METROPOLITAN GOVERNMENT OF NASHVILLE AND DAVIDSON COUNTY

STAFF RECOMMENDATION
2802 Hawthorne Place
March 20, 2013

Application: New construction—addition and ridge raise
District: Belmont-Hillsboro Neighborhood Conservation Zoning Overlay
Council District: 18
Map and Parcel Number: 11704022400
Applicant: Josh Belville, Stone Oak Builders
Project Lead: Melissa Baldock melissa.baldock@nashville.gov

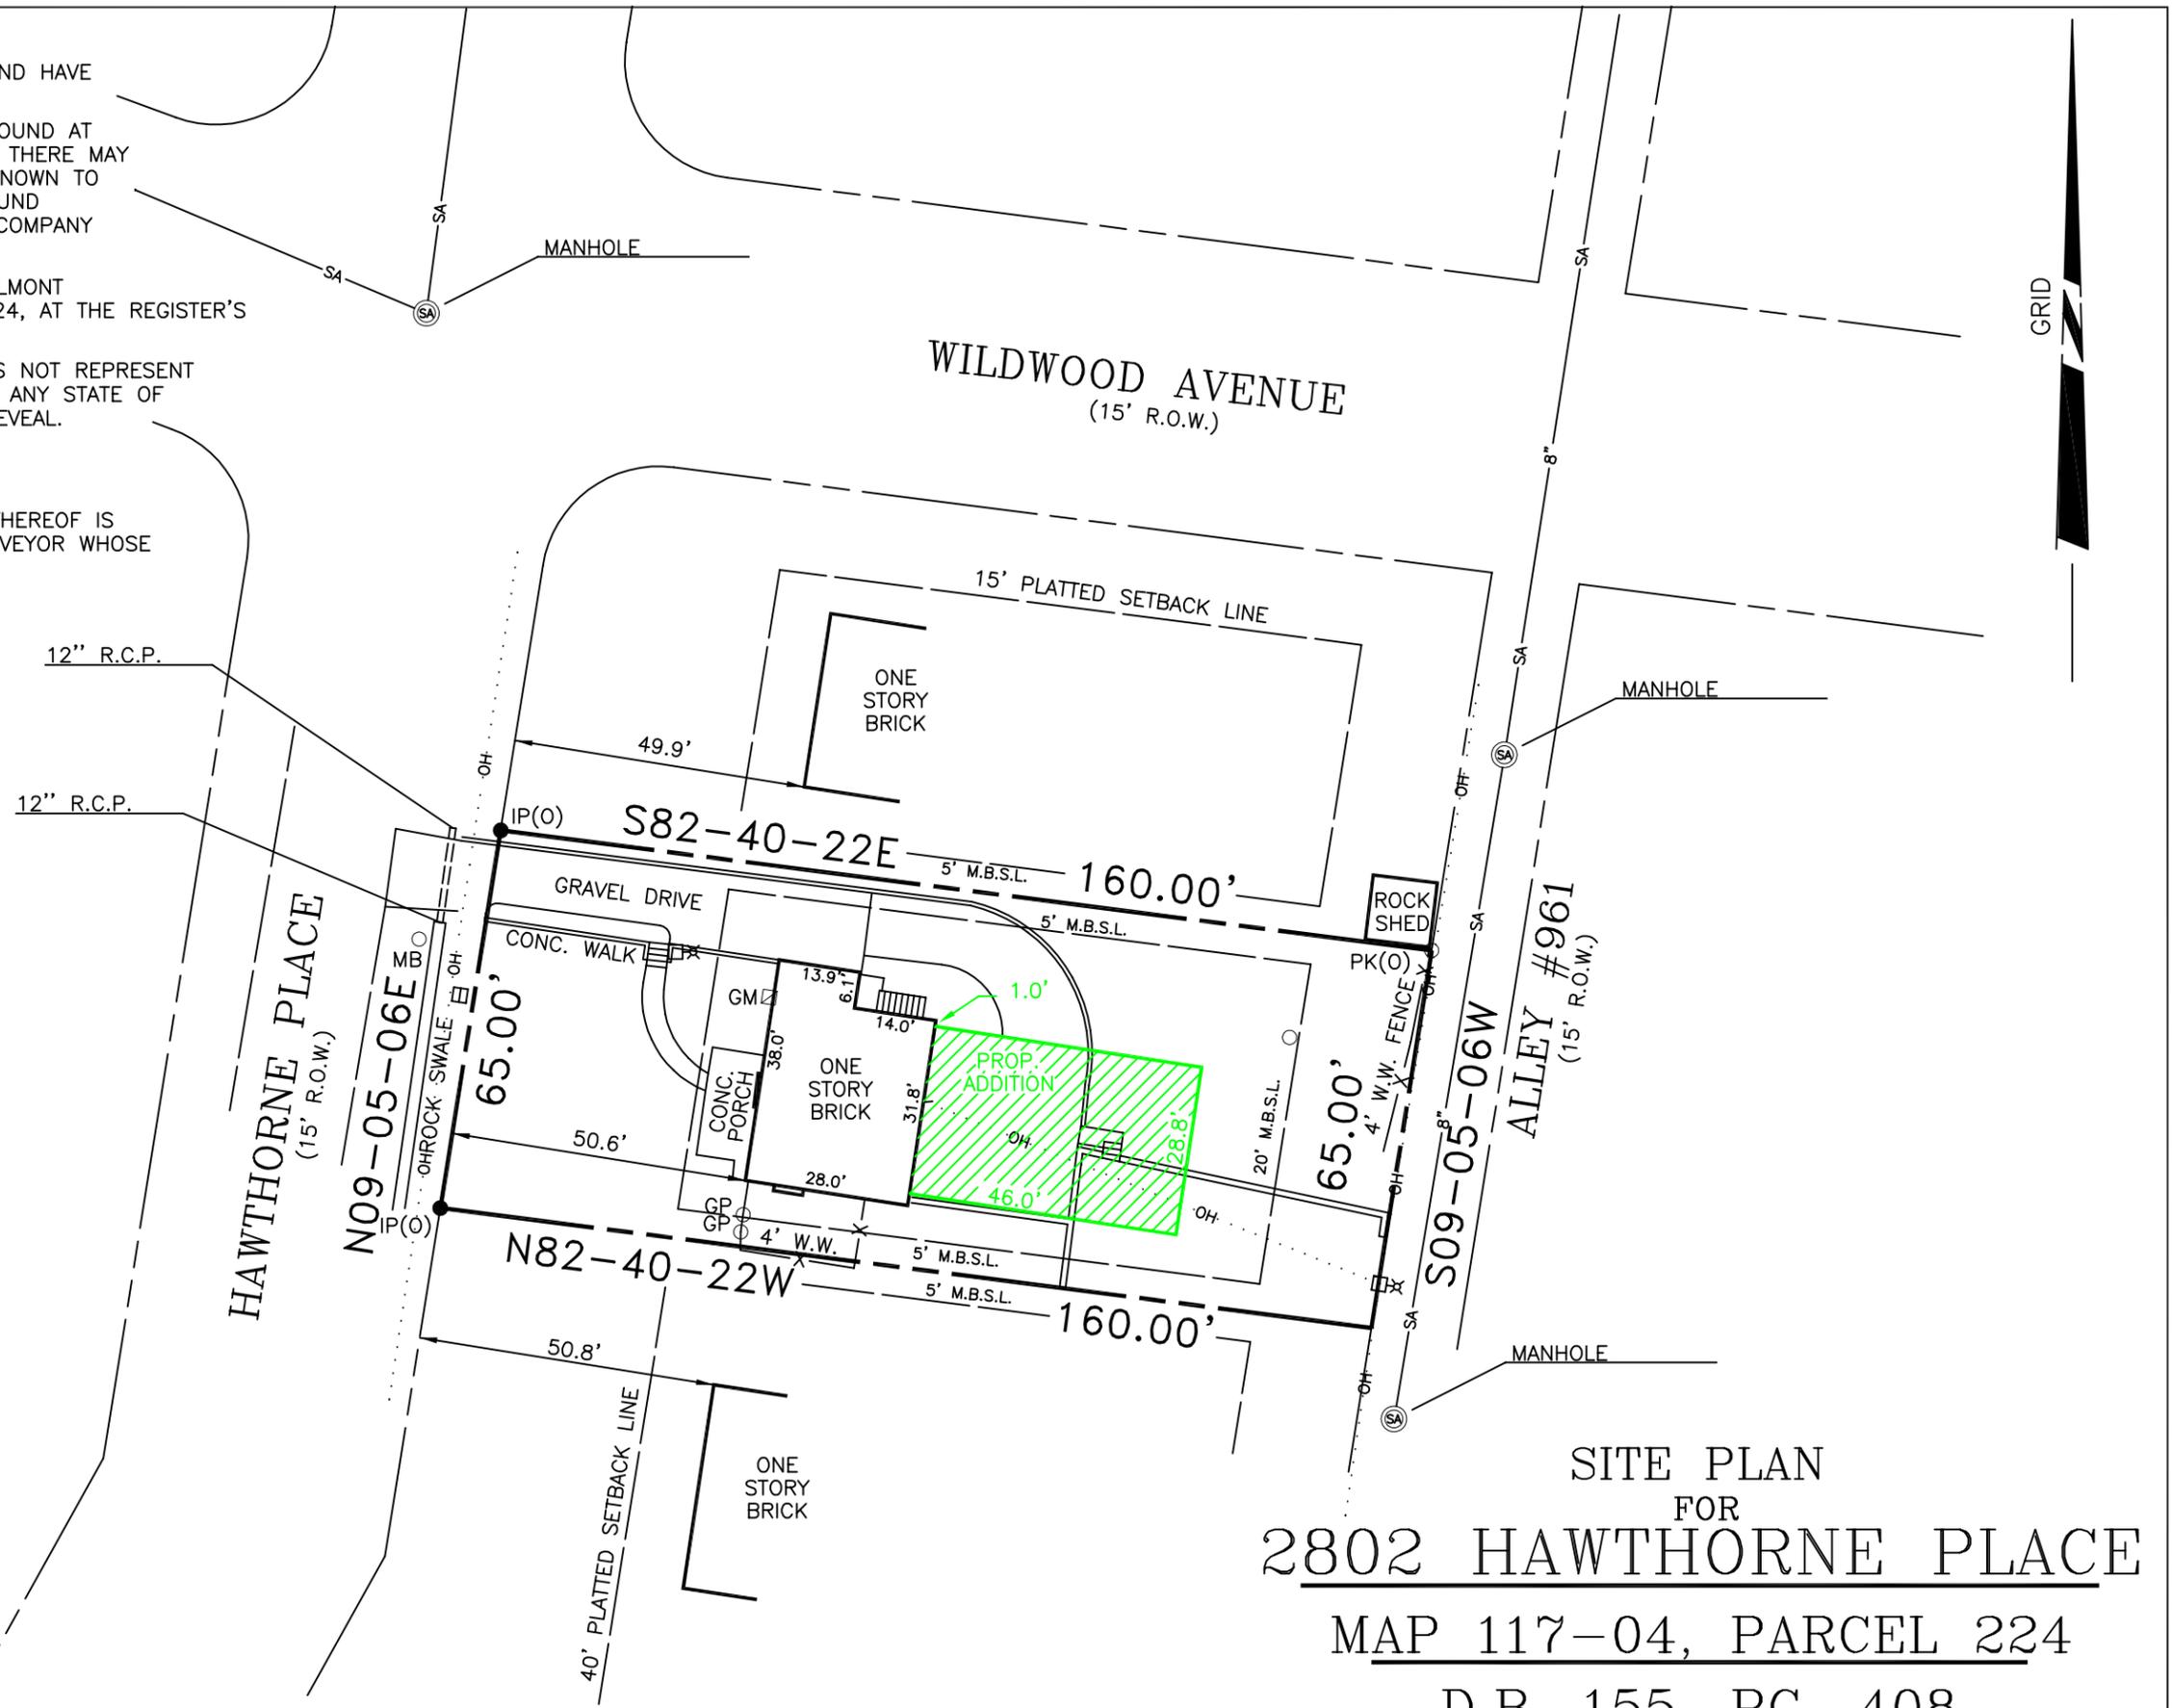
Utilities. The drawings do not indicate the location of the utilities, and staff asks that the utilities be placed in the rear of the house or on a side façade, beyond the midpoint of the house.

Attached Garage: An attached garage is proposed for the addition’s left facade. The design guidelines state that an attached garage can be appropriate when “*the location of the attached garage is in the general location of an historic accessory building, the new garage is located in the basement level, and the vehicular access is on the rear elevation.*” In this instance, there is an existing attached garage on the rear façade, making an attached garage appropriate. The garage is located at the basement level, although on the side, not the rear façade. Staff finds the location of the garage on the side façade to be appropriate because it is located towards the back of the house, over fifty feet (50’) from the front of the house, and because it will be inset by over seven feet (7’) from the front wall of the house. The garage doors will be at most minimally visible. The garage will be accessed via an existing curb cut and driveway.

Staff finds that the attached garage meets Section II.B.1.i. of the design guidelines

Recommendation Summary: Staff recommends approval of the addition and ridge raise with the conditions that:

1. The side chimney be retained;
2. Most of the window openings on the side façade remain unaltered;
3. The stone foundation remain and more information be provided on how the foundation will be treated and repaired once the exterior stair is removed;
4. More information be provided on the brick on the house’s left elevation;
5. Staff approve the asphalt shingle color and window and door specifications; and,
6. The utilities be placed in the rear of the house or on a side façade, beyond the midpoint of the house.

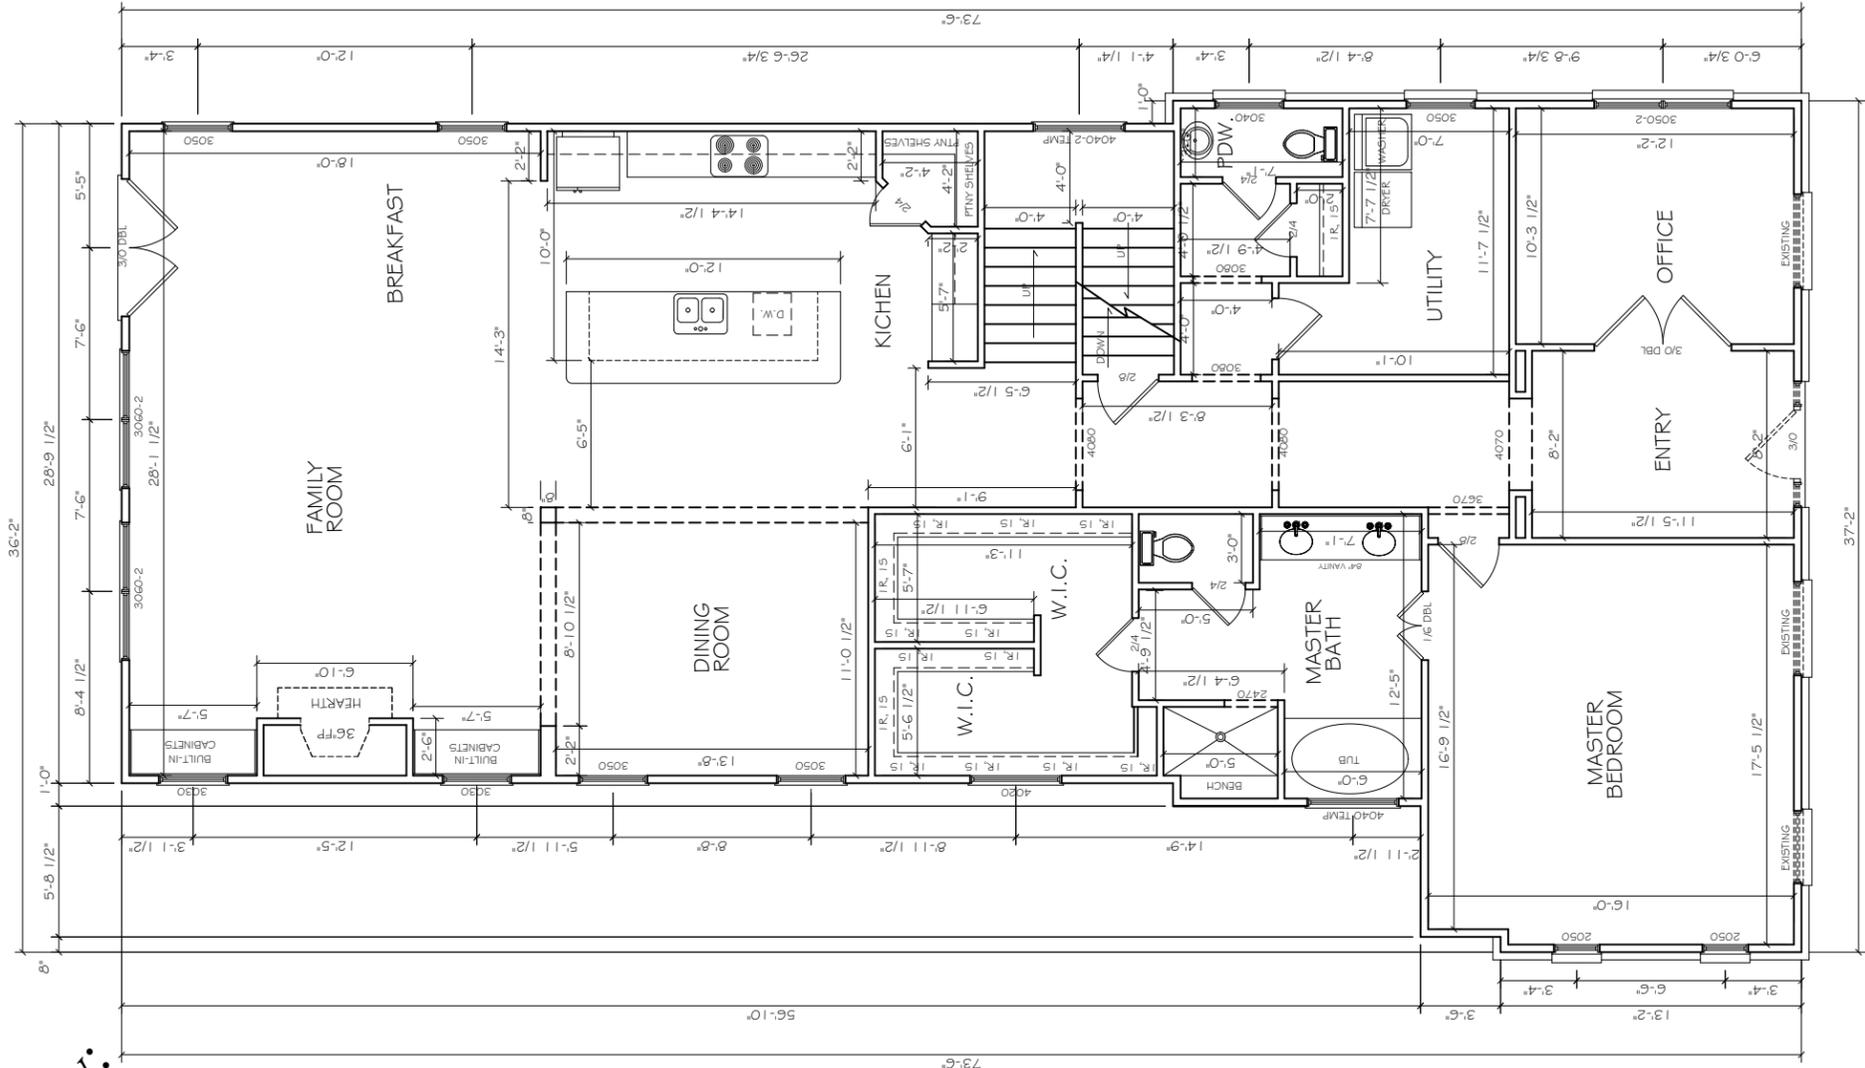
Ridge Raise: The project involves a ridge raise for the side-gabled roof. The ridge raise will step in two feet (2') from the sidewalls of the house and will increase the height of the roof by two feet (2'). Staff finds that the ridge raise meets Section II.B.2. of the design guidelines.

Height, Scale: The site slopes down from the front of the house to the back of the house. The new addition will match the height of the ridge raise and will therefore be two feet

(2') taller than the historic house. The addition's foundation line will match that of the historic house.

The addition steps in from the side walls of the house appropriately. It is inset one-foot (1') from both the right and left sidewall for the entire depth of the addition. The addition will have a maximum depth of forty-five feet, six inches (45'6"), and a maximum width of twenty-eight feet, nine inches (28'9"). The addition will add approximately one thousand, three hundred and eight square feet (1,308 sq. ft.) to the footprint of the house. By comparison, the historic house has a width of thirty-seven feet, two inches (37'2"), a depth of twenty-eight feet, three inches (28'3") , and a footprint of approximately one thousand square feet (1,000 sq.ft). Although the addition will more than double the size of the house, staff finds it to be appropriate because the house is unusually shallow. In addition, once the addition is constructed, the site's percentage of open space will still fall within the typical range for the immediate vicinity. Once the new addition is constructed, the site's percentage of open space will be reduced from ninety percent (90 %) to seventy-seven percent (77 %). By comparison, the lots in the immediate vicinity typically have percentages of open space ranging from seventy-three percent to ninety-two percent (73%- 92%) open space.

Roof Form: The existing house's primary roof form is a side gable with a slope of 8:12. The addition's primary roof form will be a front-facing gable with a slope of 8:12. On the side elevations, there will be several gabled dormers with a roof slope of 3:12. The dormers will be set off the side wall of the addition by one foot (1') and will therefore be two feet (2') from the back wall of the house. Staff finds that the roof form is compatible

Proportion and Rhythm of Openings: The alteration of the windows on the existing house is discussed under “Partial Demolition.” Most windows on the addition are twice as tall as they are wide, with the exception of some smaller openings that will be only minimally visible. There are no large expanses of wall space without a door or window opening. Staff finds that the addition’s proportion and rhythm of openings meet Section II.B.1.g. and II.B.2. of the design guidelines.
